VALUE ENGINEERING STUDY
OF
I-64 MAJOR WIDENING

ITEM NUMBERS: 5-2035.40, 5-2035.70 & 5-65.40/.41 Extension

January 12-16, 2009

VE GROUP, L.L.C.

2. Value Engineering Alternative

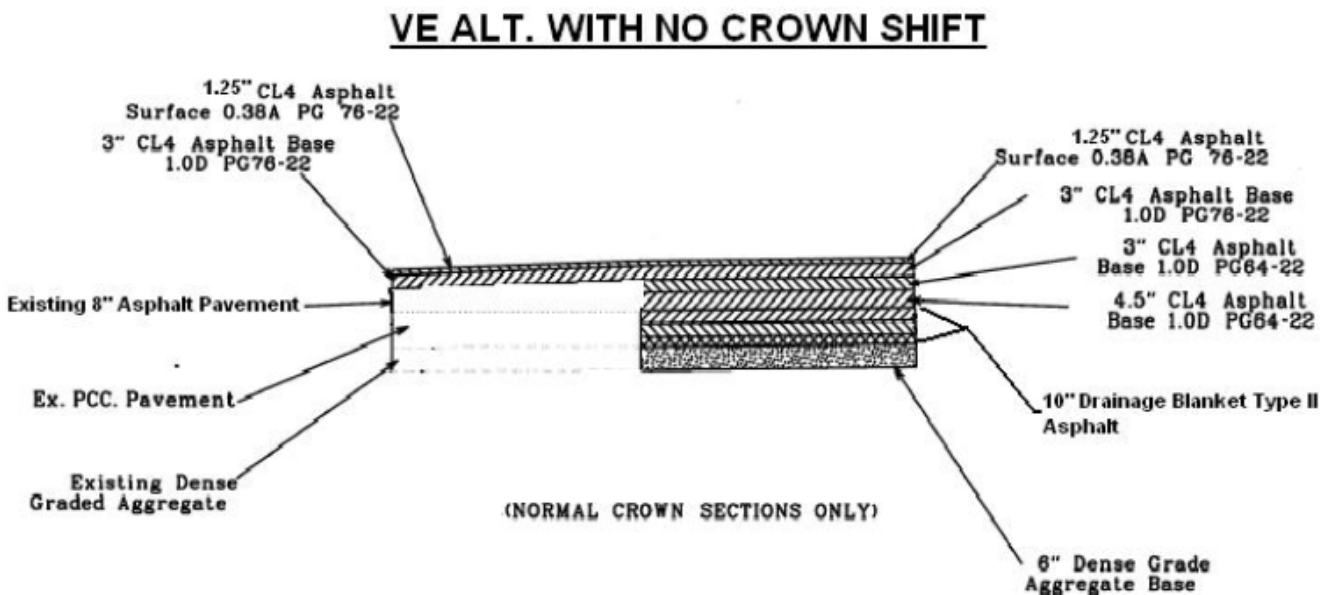
The Value Engineering team is proposing the elimination of the planned 10' crown shift in Tangent, Bifurcated sections. This change would move the crown of the road from between the slow and middle lane to the outer edge of the slow lane in the new configuration after widening. Elimination of this shift would remove the need for the 0 to 5" Level and Wedge course for crown point correction. This proposed change would also eliminate the need for a 5" lift of Asphalt base material in the widening section that was required to ensure the final grades matched.

2. *Value Engineering Alternative Number 1*

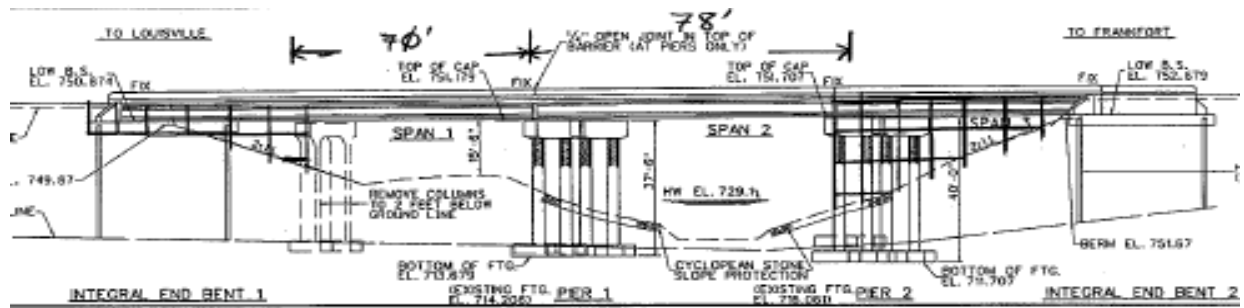
The Value Engineering recommends constructing a single span bridge to cross Hardinsville Ballard Road. It is recommended that the approximate 80' wide Goose Creek span be cleared by utilizing a triple 13'x11' box culvert. The Value Engineering Alternative will reduce approximately 138' of bridge length; eliminate the piers; decrease construction duration; decrease construction cost; and future maintenance needs. The feasibility of utilizing a culvert to bridge Goose Creek must be further analyzed before selecting this alternative. Permitting issues may preclude this alternative's selection.

VALUE ENGINEERING ALTERNATIVE NUMBER 2 I-64 BRIDGE OVER GOOSE CREEK AND HARDINSVILLE BALLARD ROAD

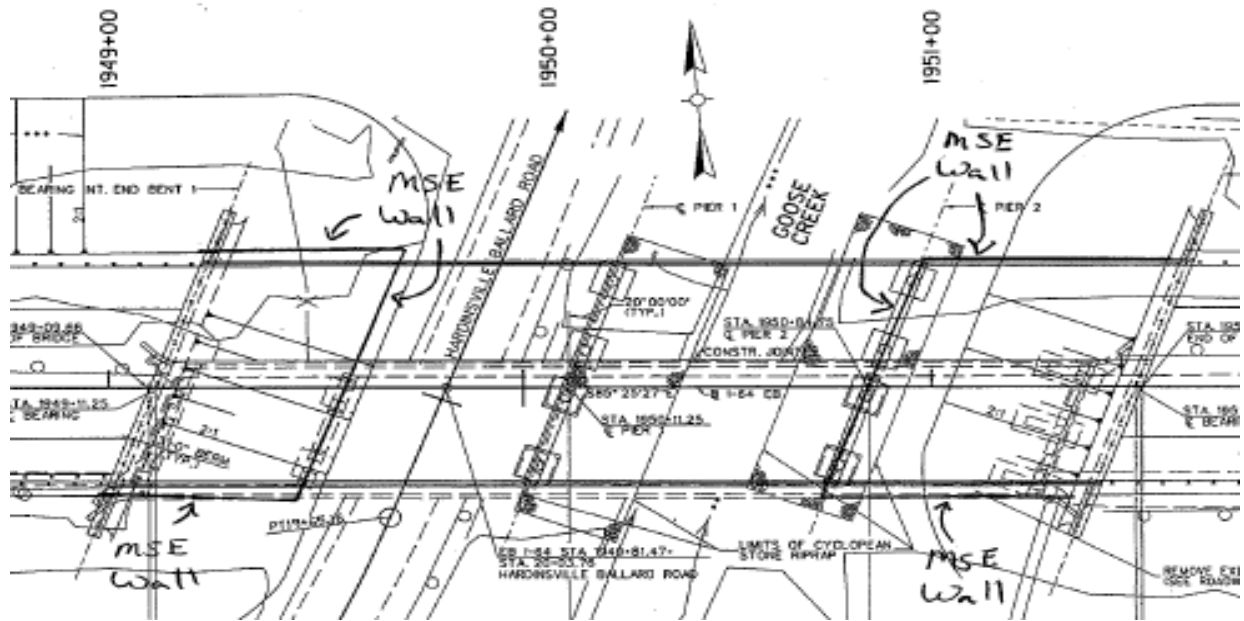
The Value Engineering recommends constructing a two span bridge to cross Hardinsville Ballard Road and Goose Creek with MSE walls constructed beyond the flood zone. This bridge would have spans of approximately 70' and 78', totaling 148'. The 70' span would clear the Hardinsville Ballard Road while the 78' span would cross Goose Creek. The Value Engineering Alternative will eliminate a pier; decrease construction cost; and future maintenance needs.

VALUE ENGINEERING ALTERNATIVE GOOSE CREEK CROSSING

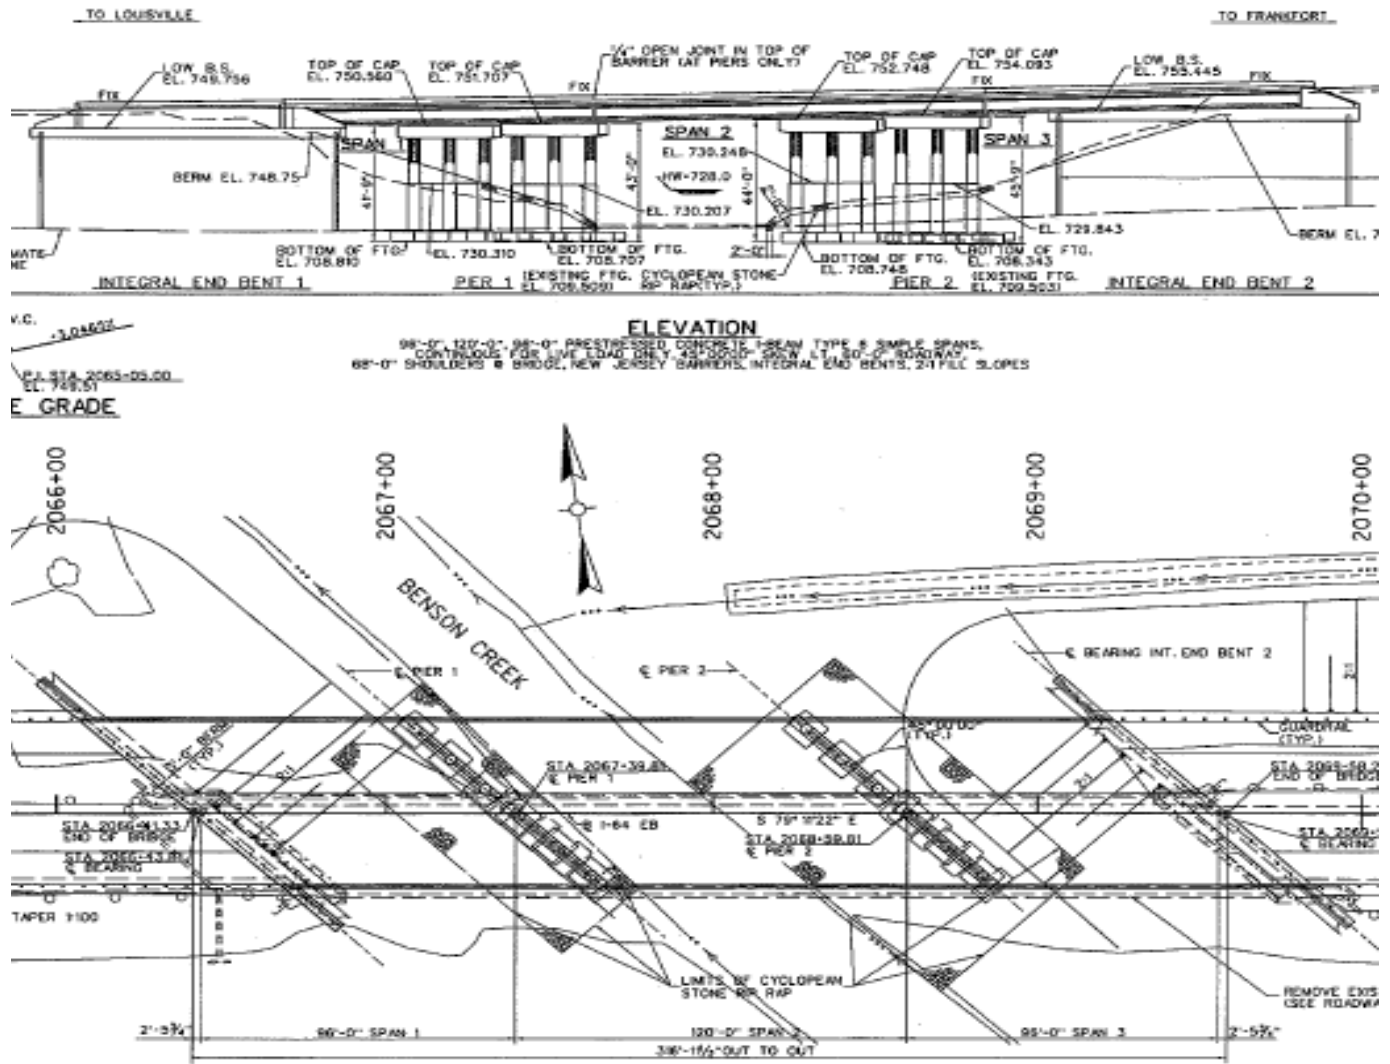
The Value Engineering Team Recommends replacing the twin bridges over Hardinsville Ballard Road and Goose Creek with precast culverts. These culverts will be approximately 324' long; and the Hardinsville Ballard Road CONSPAN Culvert will be 32' wide and 18' high with the Goose Creek BEBO Culvert will be 42' wide and 12' high as shown below.

I-64 will be constructed on the embankment over the culverts and will consume some of the excess excavation material on the project. It will also eliminate the bridge maintenance requirement and the risk of the bridge deck freezing before the pavement.

These culverts can be constructed early in the project and fill material placed in the median to provide for temporary/permanent pavement placement to 2-lanes of traffic in each direction. The bridges can be demolished and the remainder of the fill and pavement can be placed.

**VALUE ENGINEERING ALTERNATIVE NUMBER 2
 I-64 BRIDGE OVER BENSON CREEK**

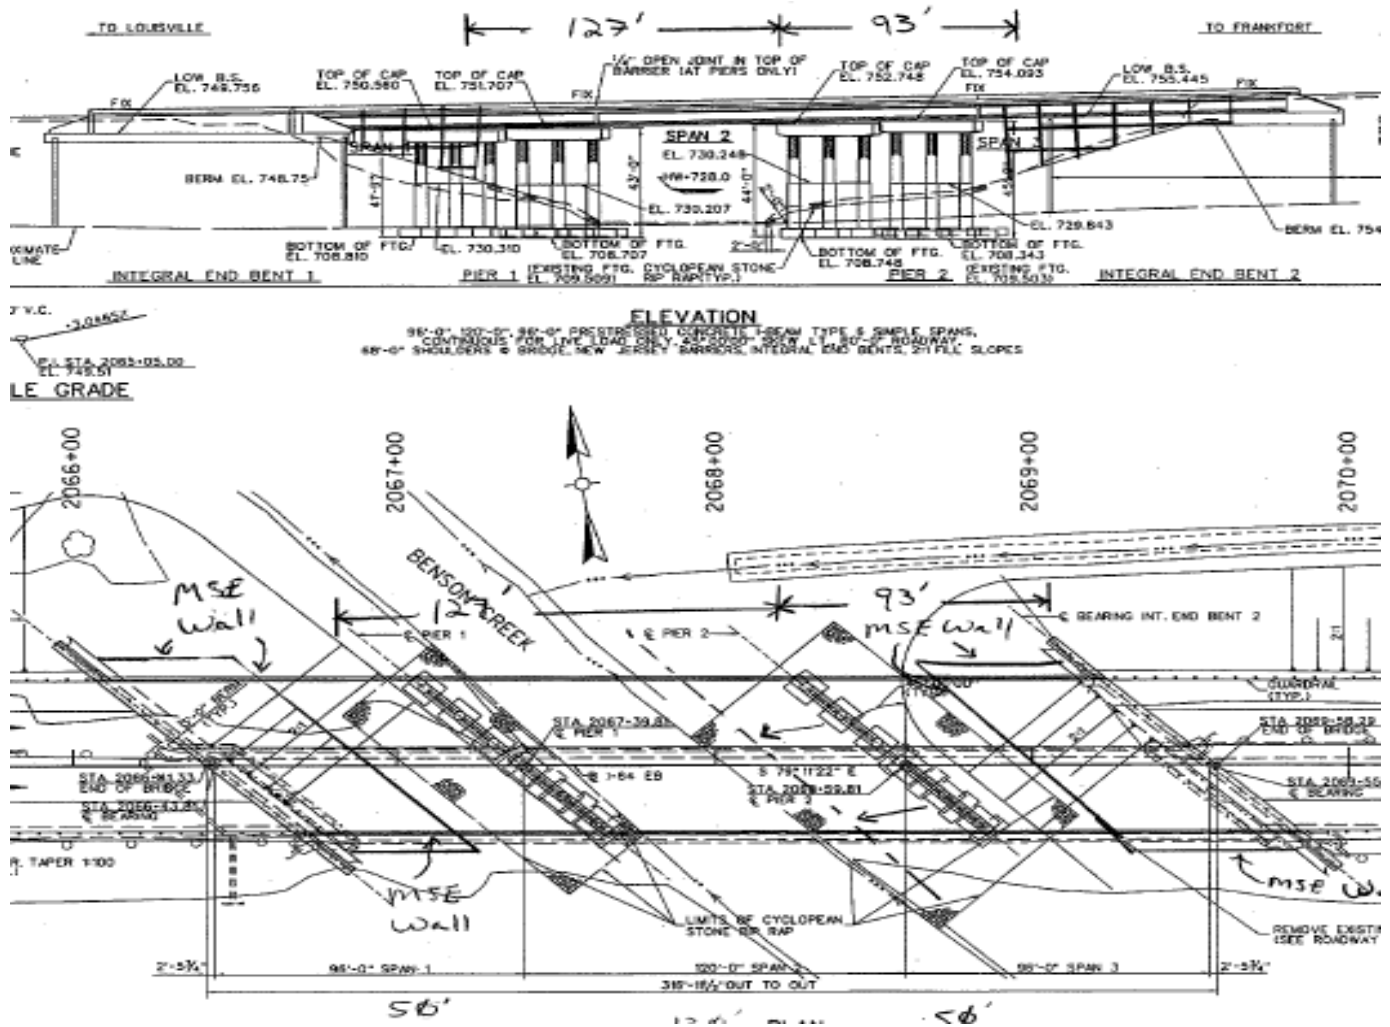
The Value Engineering recommends constructing a two span with 127' and 93' for a total of 220' to bridge Benson Creek with MSE walls. The Value Engineering Alternative will eliminate a bridge pier; decrease construction cost; and future maintenance needs. In order to maintain adequate hydraulic flow area and to avoid scour issues, the walls must be constructed outside of the flood zone.

VALUE ENGINEERING ALTERNATIVE NUMBER 2
I-64 BRIDGE OVER SOUTH BENSON CREEK

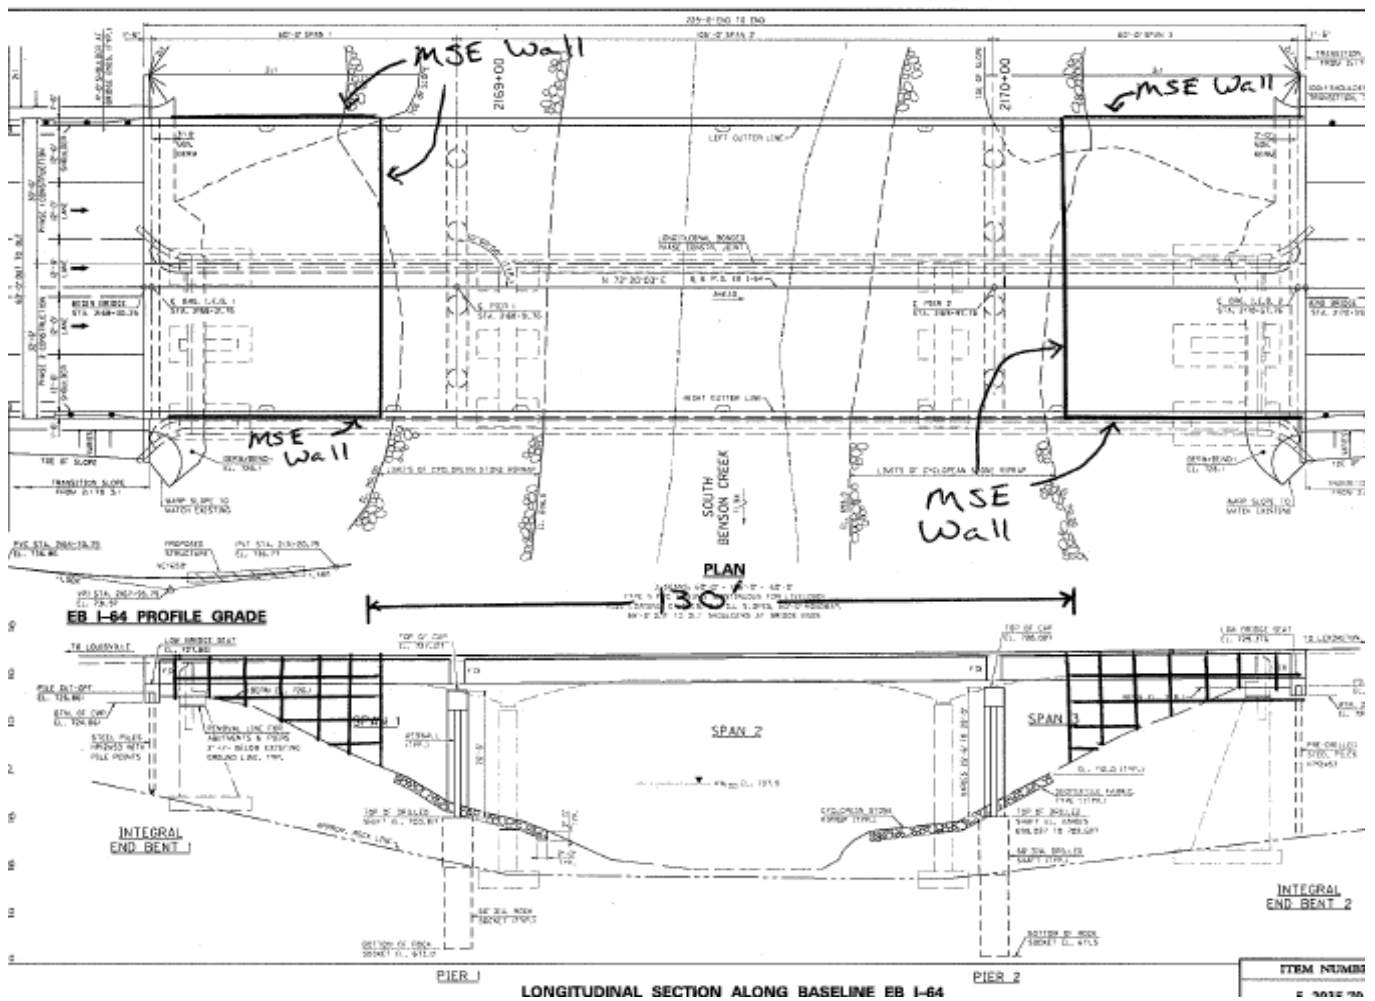
The Value Engineering recommends constructing a single span of 130' to bridge South Benson Creek with MSE walls. The Value Engineering Alternative will eliminate bridge piers; decrease construction cost; and future maintenance needs. In order to maintain adequate hydraulic flow area and to avoid scour issues, the walls must be constructed outside of the flood zone.

VALUE ENGINEERING ALTERNATIVE
I-64 BRIDGE OVER KY 151

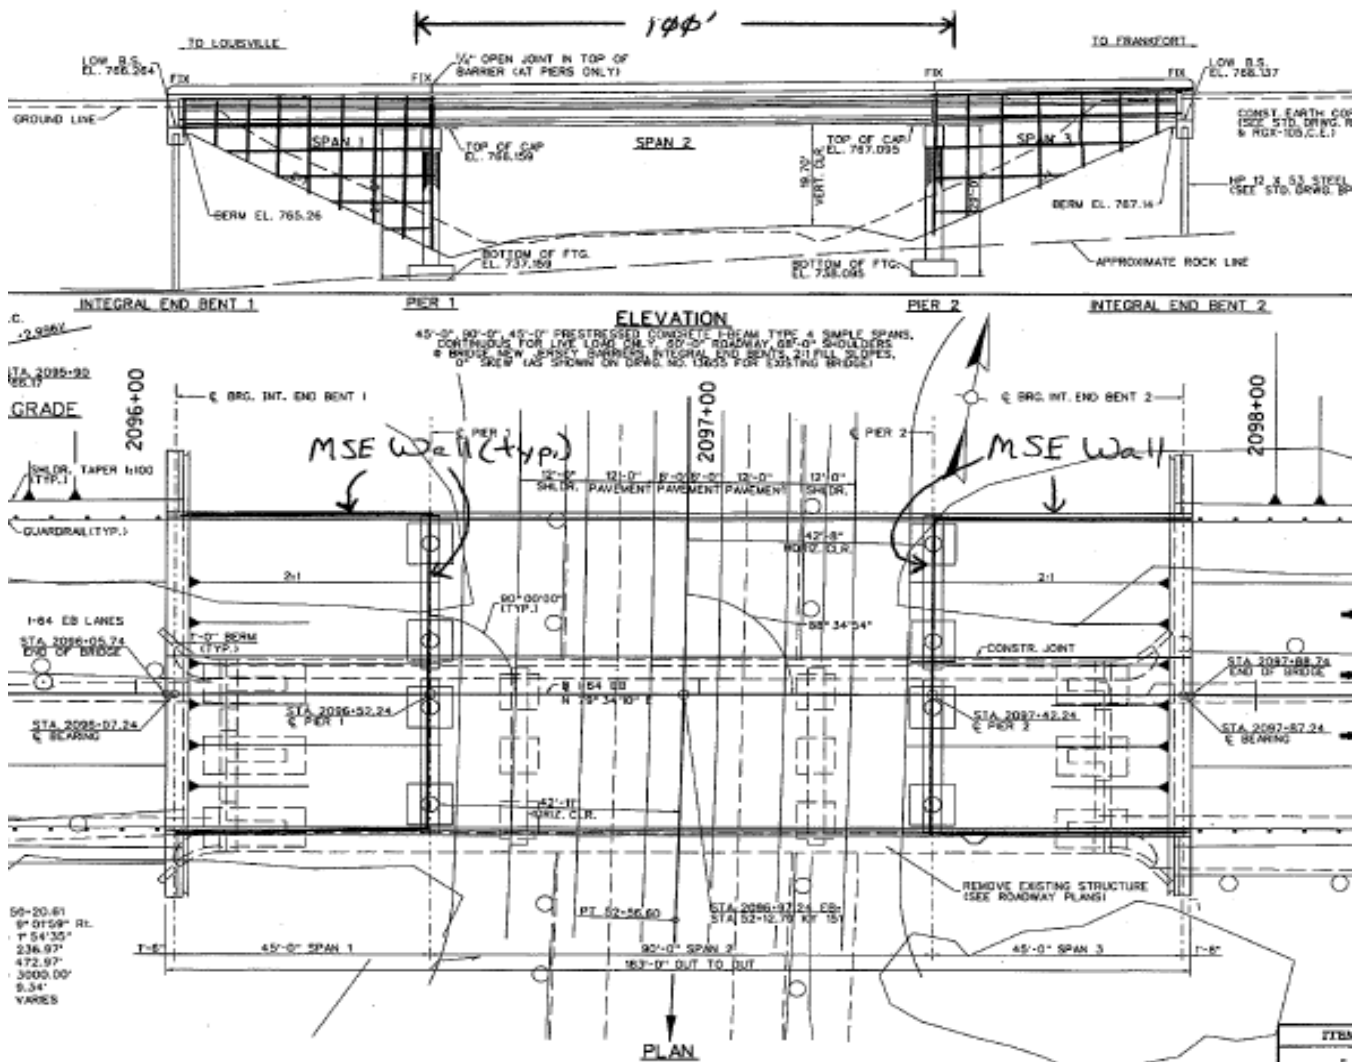
The Value Engineering recommends constructing a single span of 100' to bridge KY 151 with MSE walls. The Value Engineering Alternative will eliminate bridge piers; decrease construction cost; and future maintenance needs.

**VALUE ENGINEERING ALTERNATIVE
I-64 BRIDGE OVER KY 1665**

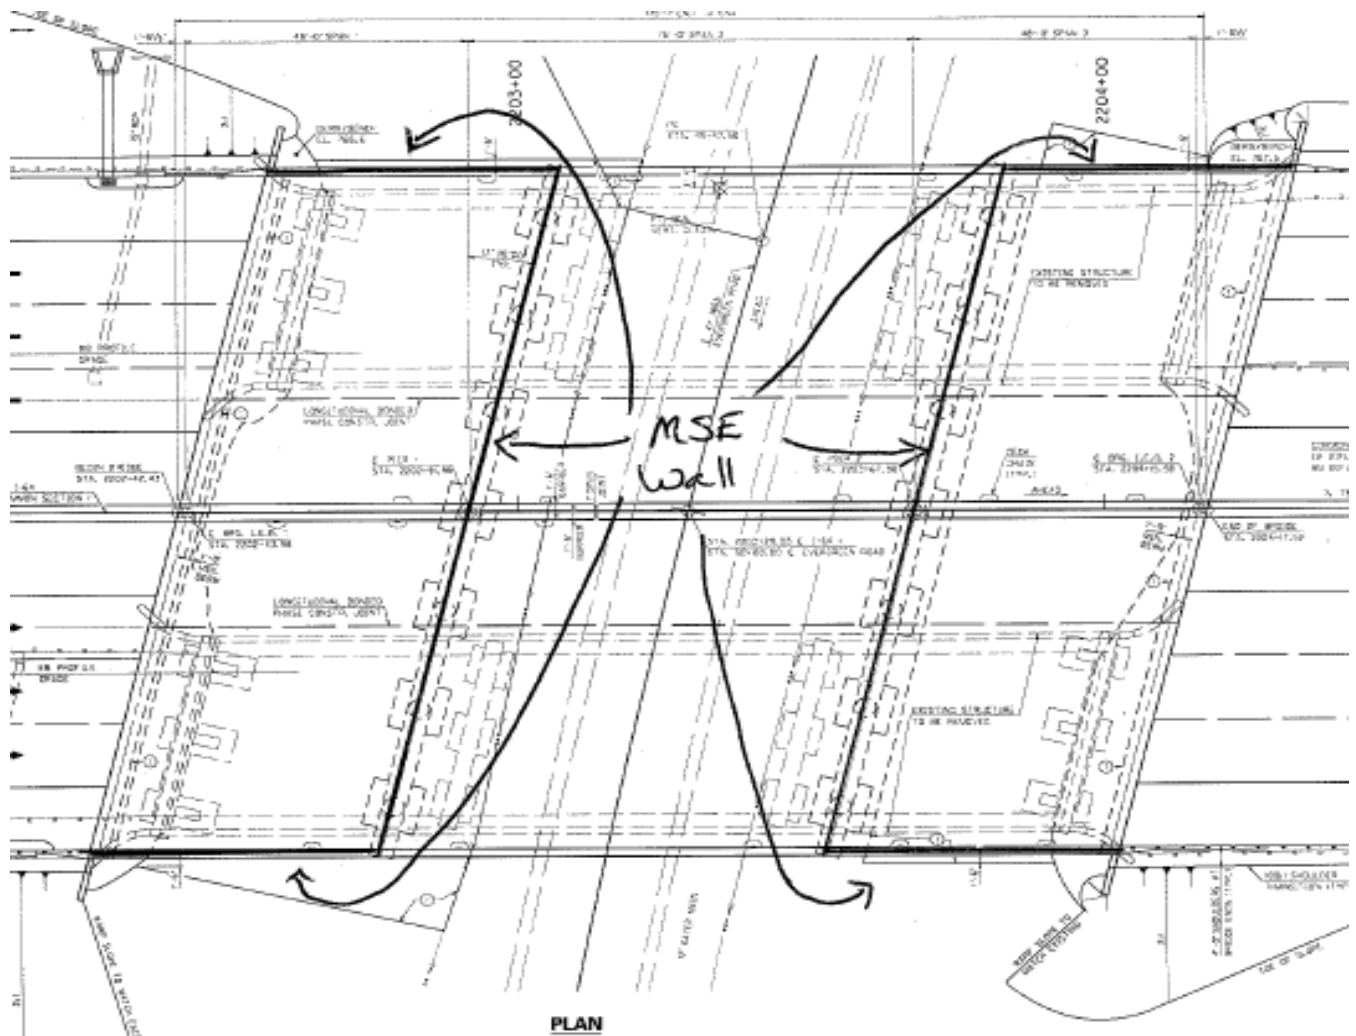
The Value Engineering Team recommends constructing a single span of 86' to bridge KY 1665 with MSE walls. The Value Engineering Alternative will eliminate bridge piers; decrease construction cost; and future maintenance needs.
